Designed: 2/25/15 TIER 3 PHASE 3 M.P.177.00 TO M.P.160.00 HSR SCOPE CHANGE Rec#: WO#:22820 IS: / /NST/JVJ	Designed: 08/21/12 TIER 3 PHASE 3 M.P. 177.00 TO M.P. 160.00 UPGRADE XINGS AND CP'S FOR HIGH SPEED RAIL Rec#: WO#: 22820 IS: /MWK / /NST/MJF	CIRCUIT MODIFICATIONS ARE NOT TO BE MADE WITHOUT AUTHORITY FROM THE OFFICE OF SIGNAL DESIGN	Date: 08/21/12 Des: NST Chk: MWK AFE: 22820	UNION PACIFIC RAILROAD BROADWELL, ILLINOIS TR 149A SPRINGFIELD SUBDIVISION Office of AVP Engineering - Signal Omaha, Nebraska	Sh.: 9D DOT 294261L MP: 161.33 ID: CSL16133.9DX

UNION PACIFIC RAILROAD

BROADWELL, ILLINOIS
TR 149A
SPRINGFIELD SUBDIVISION

Sh.:	9E
DOT	294261L
MP:	161.33
ID:	CSL16133.9EX

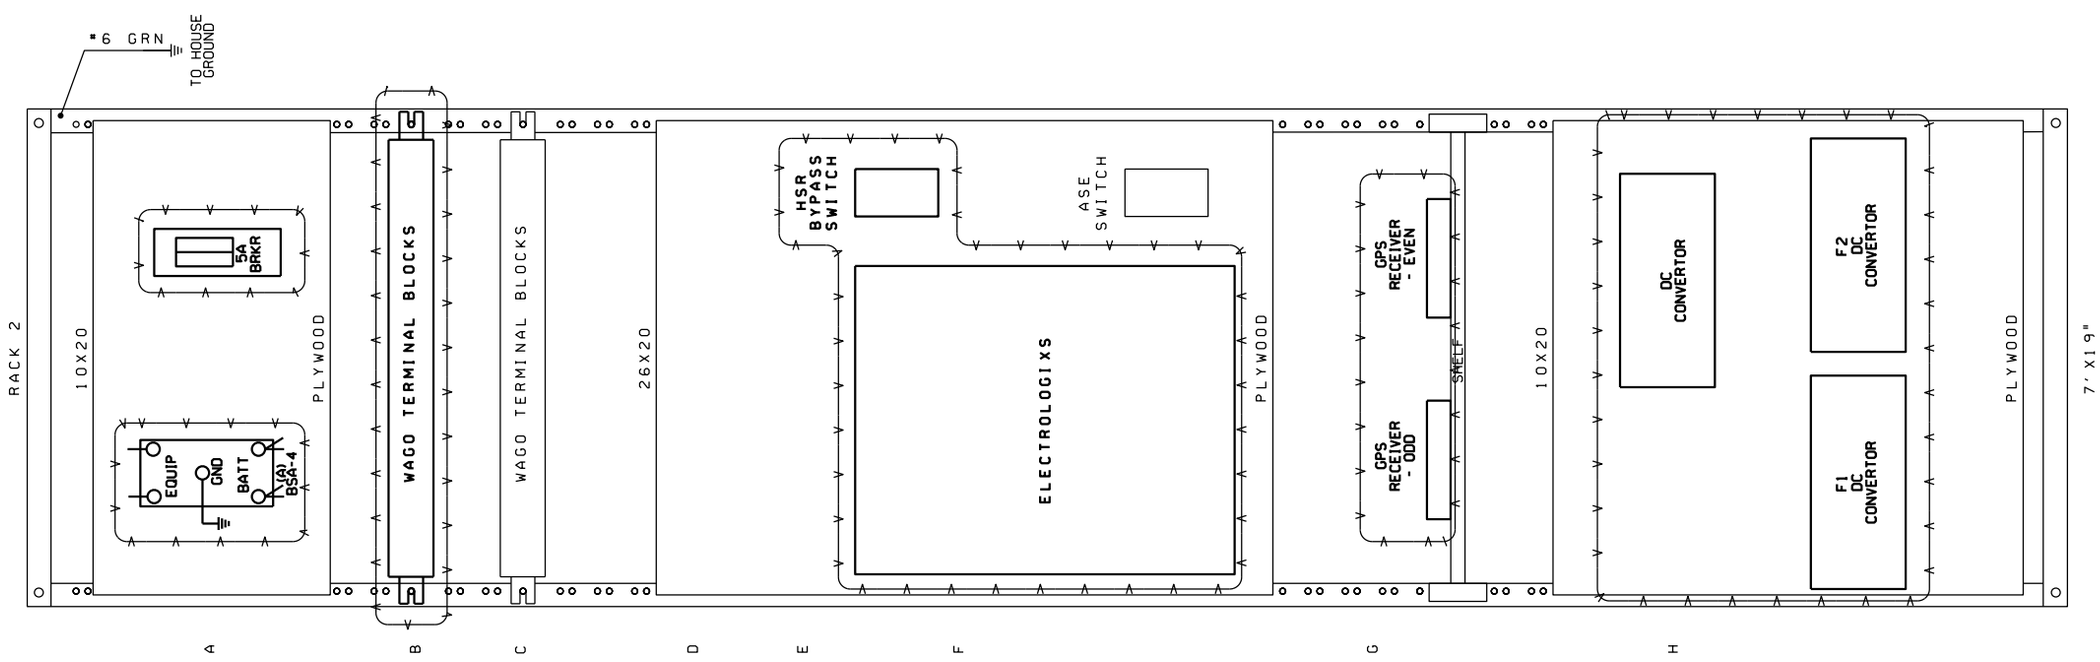
REDRAWN

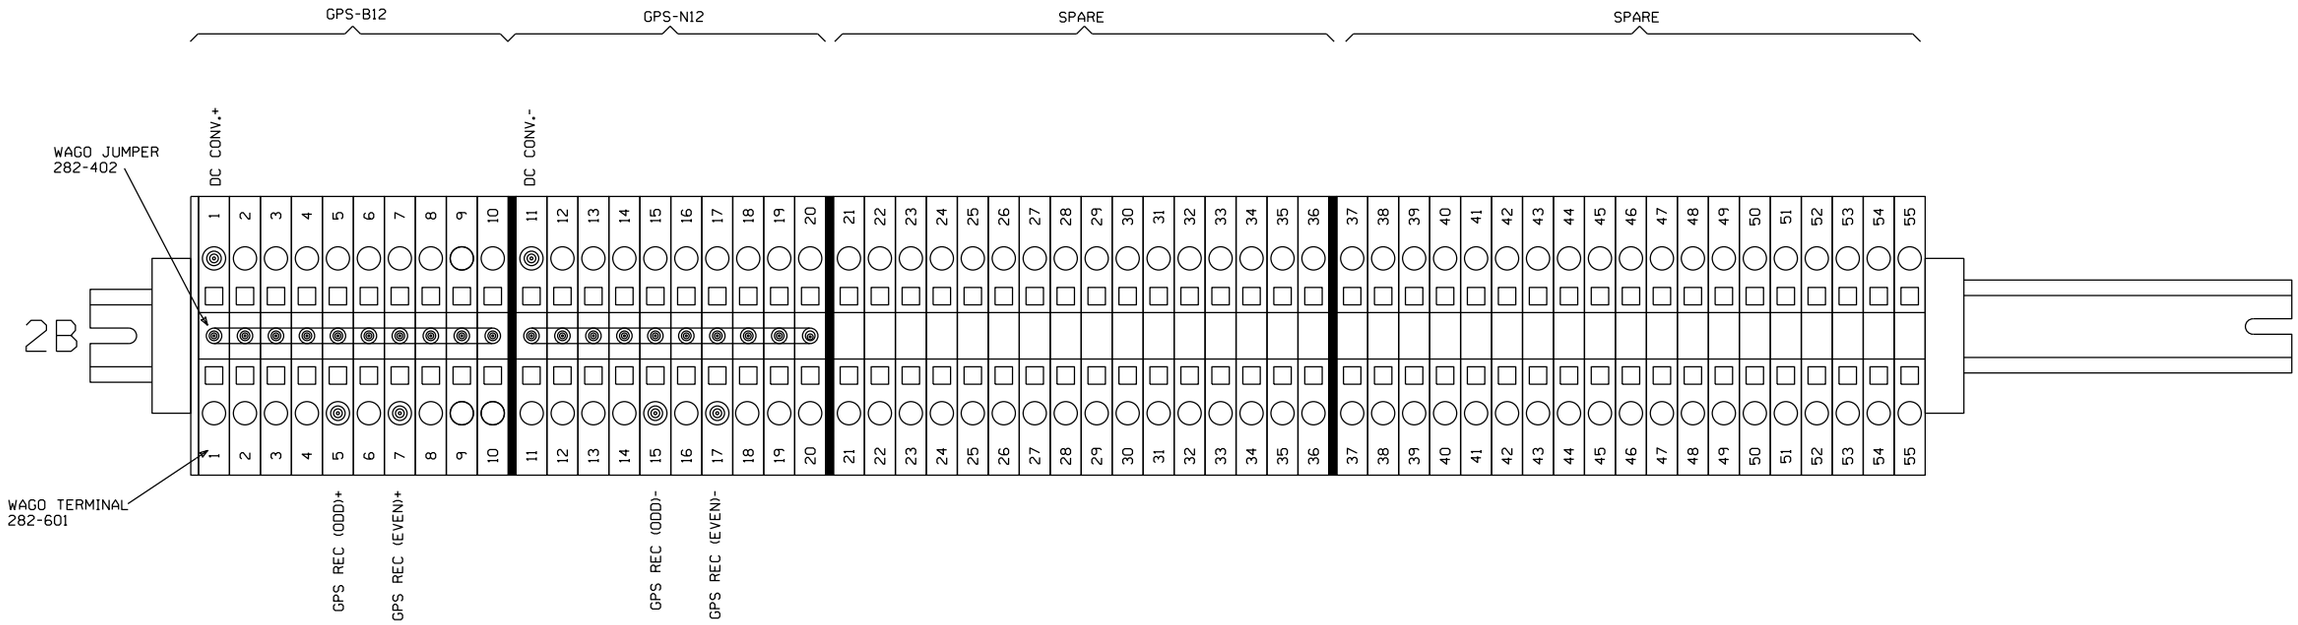
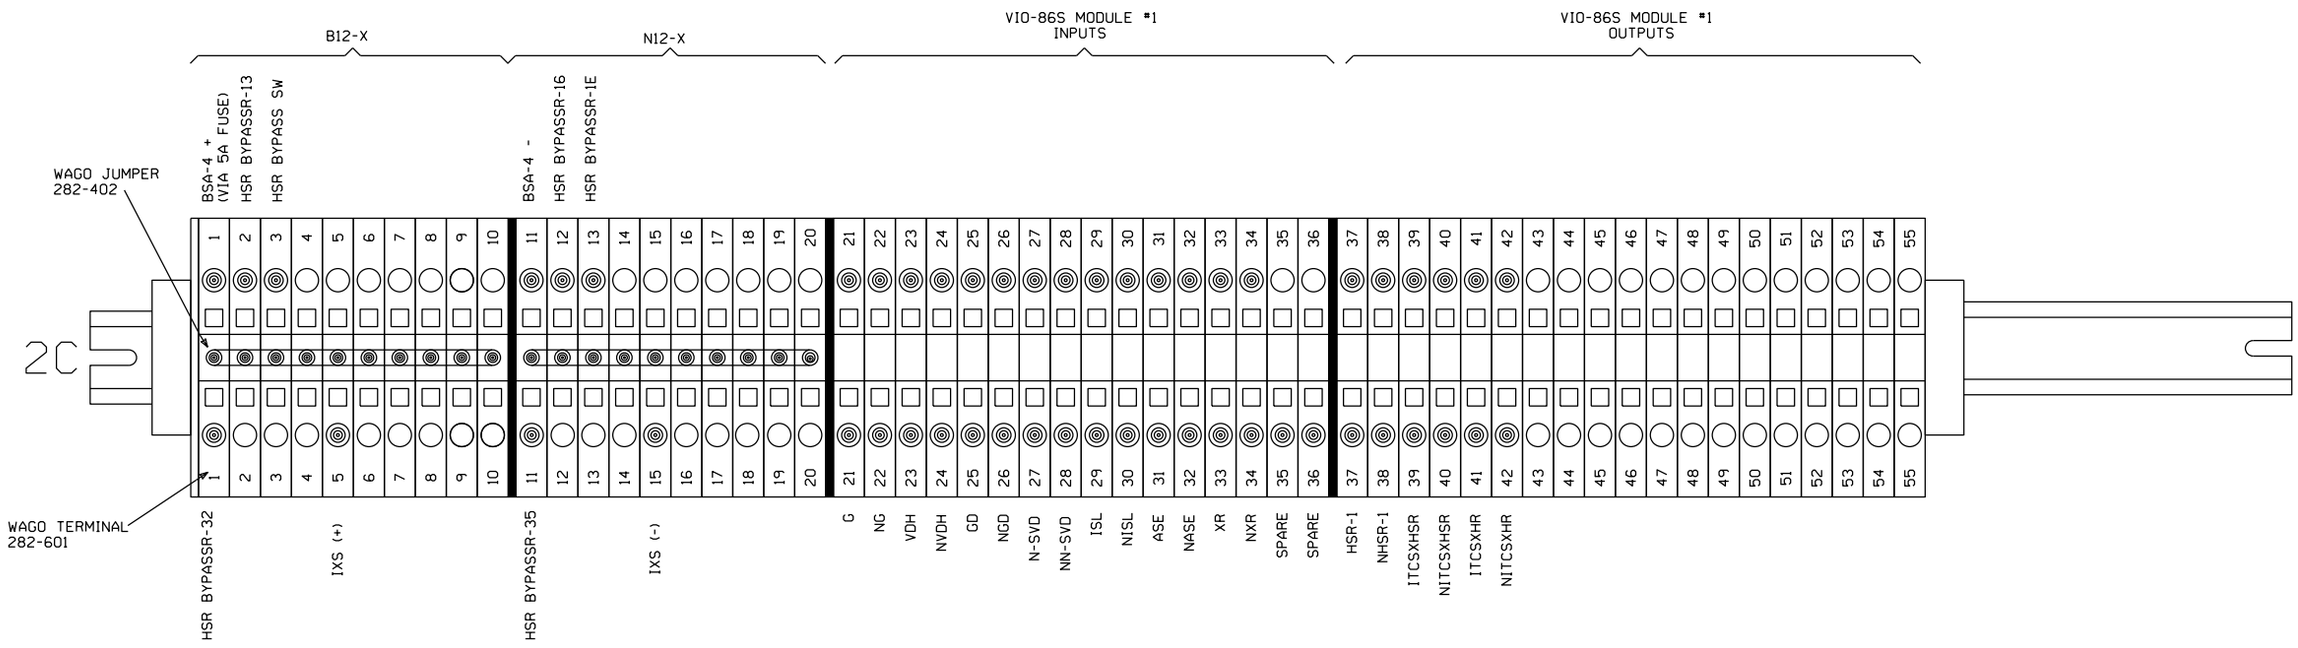
REUSED AND REDRAWN
FROM VOIDED SHT. 9E

Sh.: 10A
DOT 294261L
MP: 161.33
ID: CSL16133.10AX

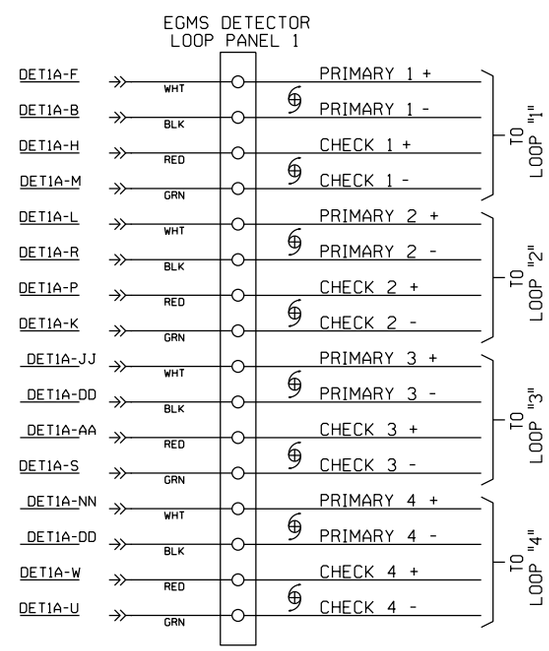
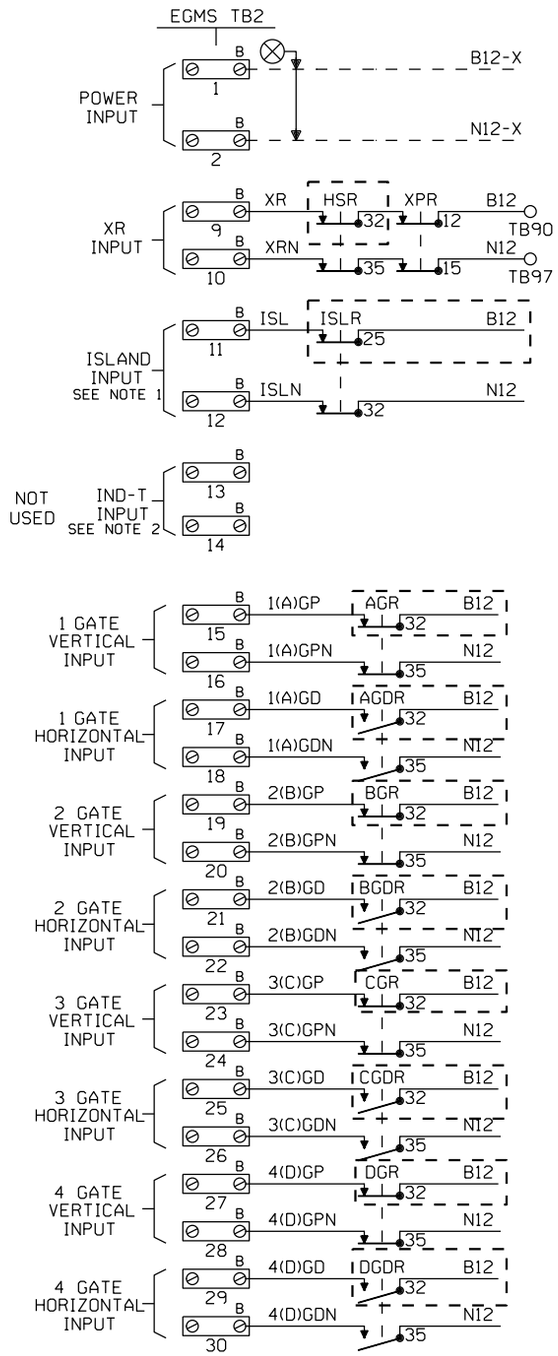
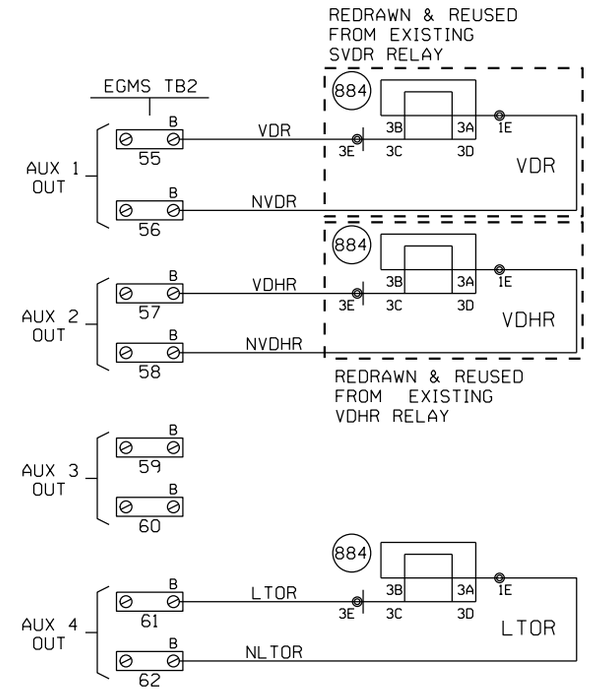
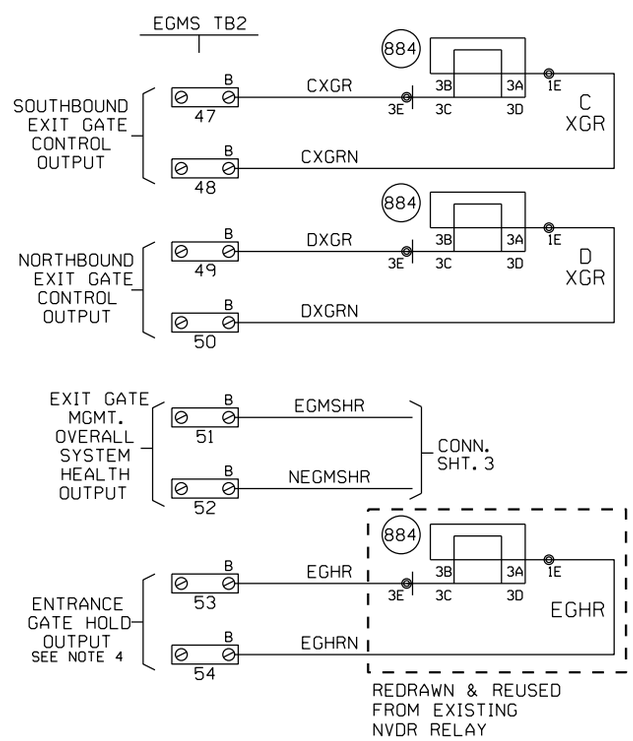
PROGRAM VERSION ~~4.3~~ 4.4

PARAMETER	
AUX OUT 1 FUNCTION	DET XRISL
AUX OUT 1 SOURCE	BOTH
AUX OUT 2 FUNCTION	DET HLTH
AUX OUT 2 SOURCE	BOTH
AUX OUT 3 FUNCTION	GP
AUX OUT 3 SOURCE	BOTH
AUX OUT 4 FUNCTION	~~ALARM~~ DET OBSTL
AUX OUT 4 SOURCE	BOTH

= IN
~~= OUT~~

~~NEW SHEET~~

Designed: 2/25/15
TIER 3 PHASE 3
M.P.177.00 TO
M.P.160.00
HSR SCOPE CHANGE
Rec#: WO#: 22820
IS: MWK/
/ /NST/JVJ

DATE 4-1-02
SHEET 3
DWG 161.30
RTE-CSL

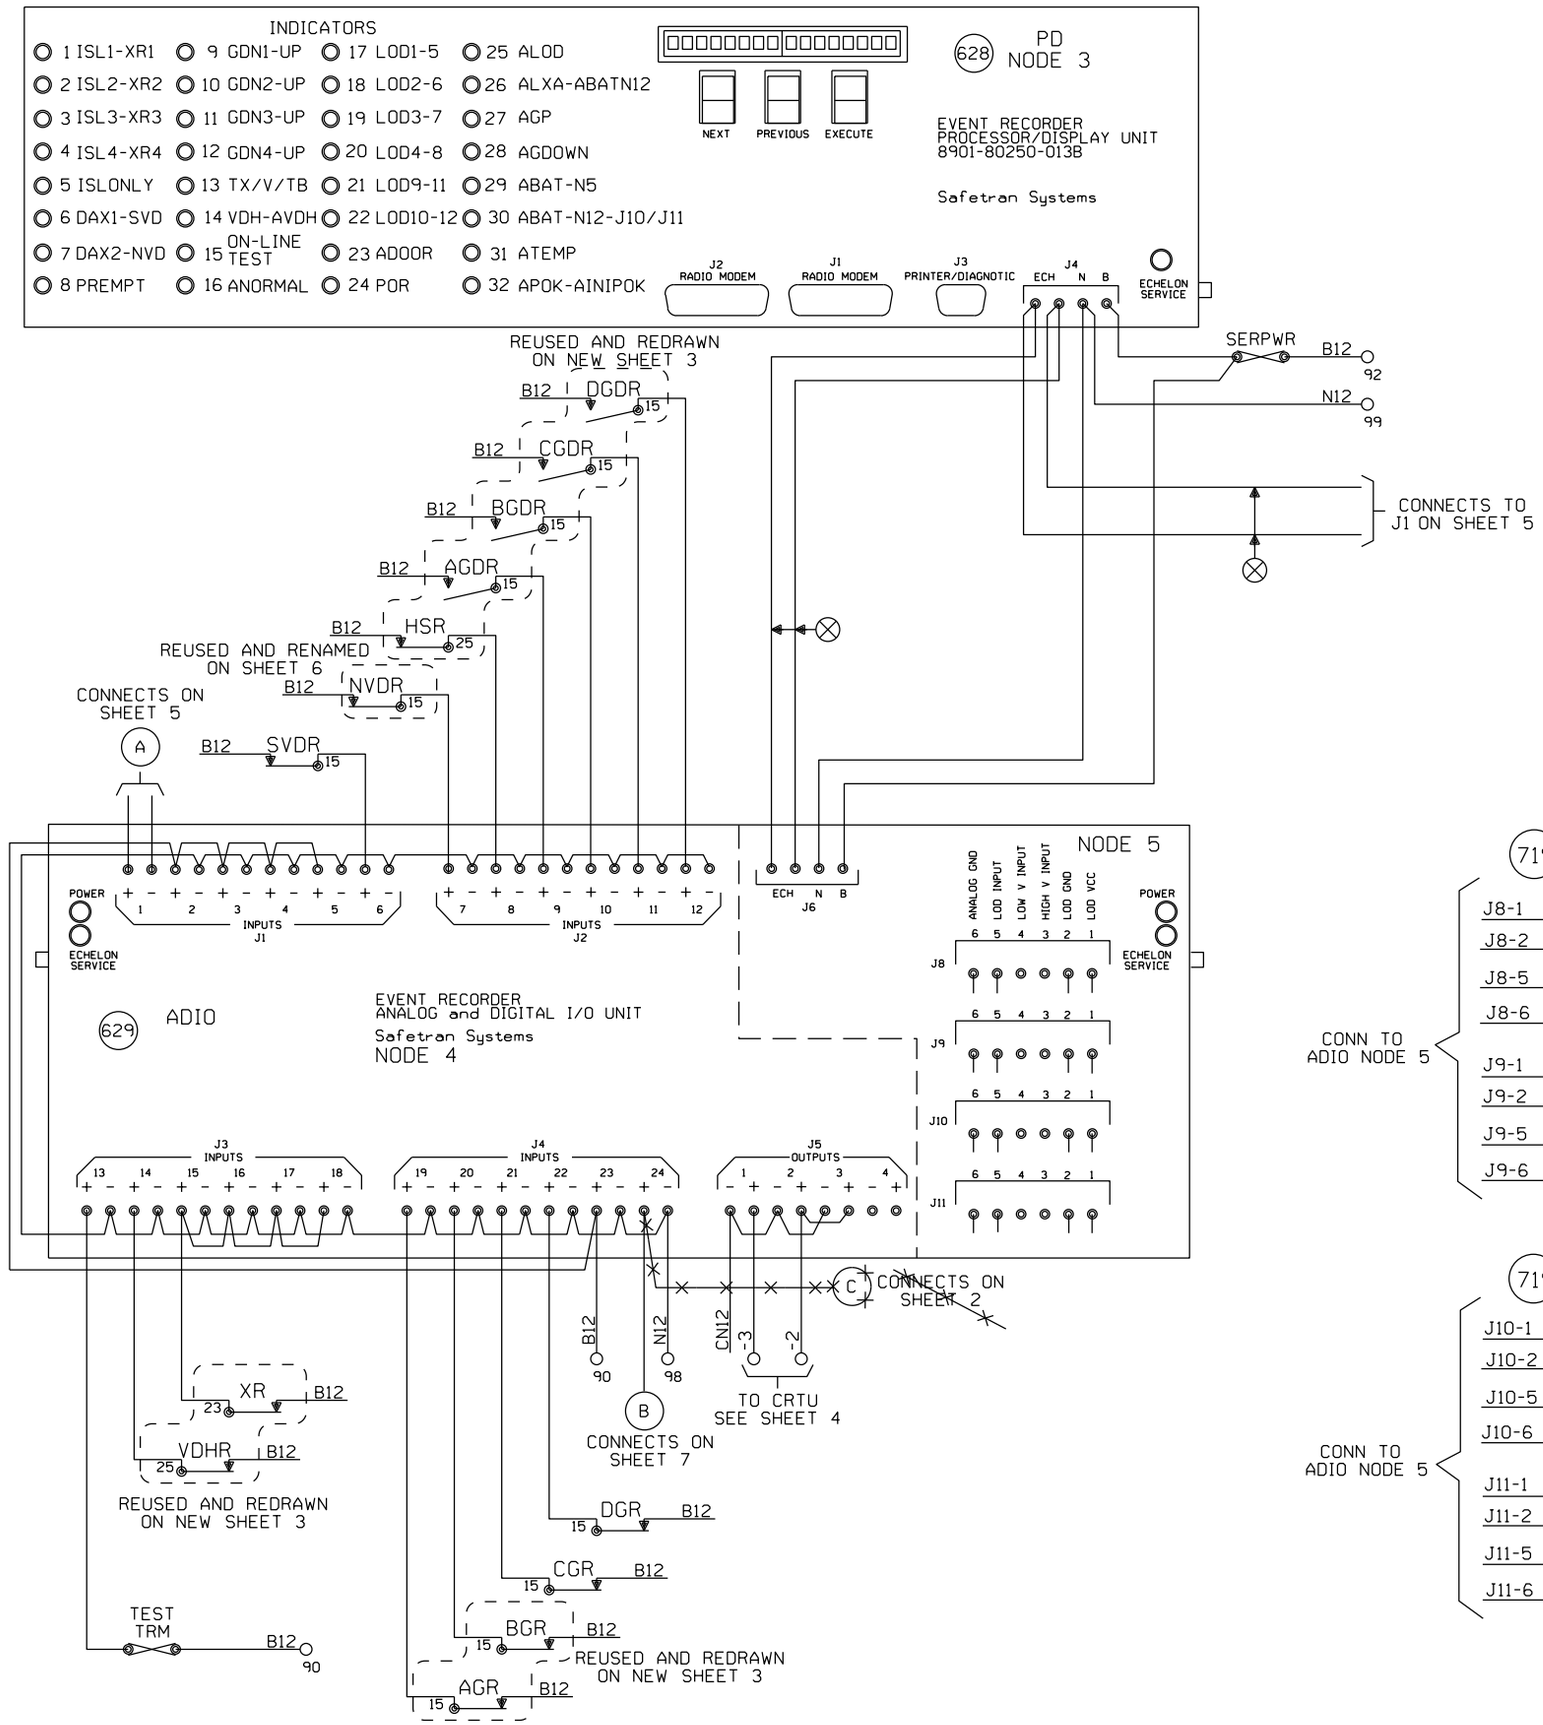
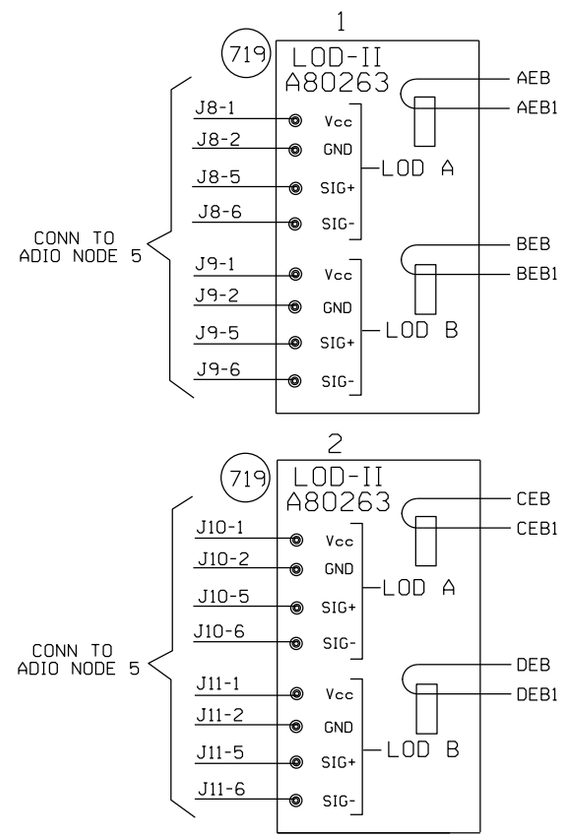
TO BE VOIDED

08/21/12
W.O. 22820 NST/MJF

DATE 4-1-02
SHEET 4
DWG 161.30
RTE-CSL

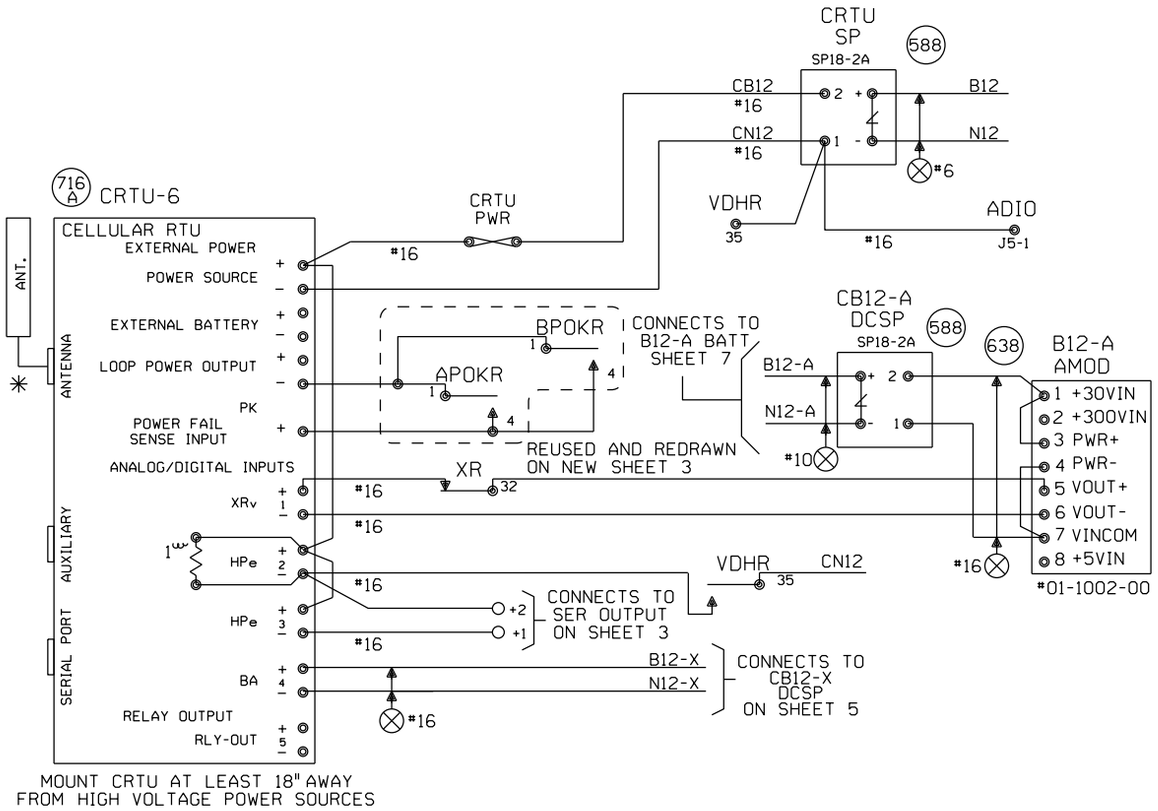
TO BE VOIDED

08/21/12
W.O. 22820 NST/MJF
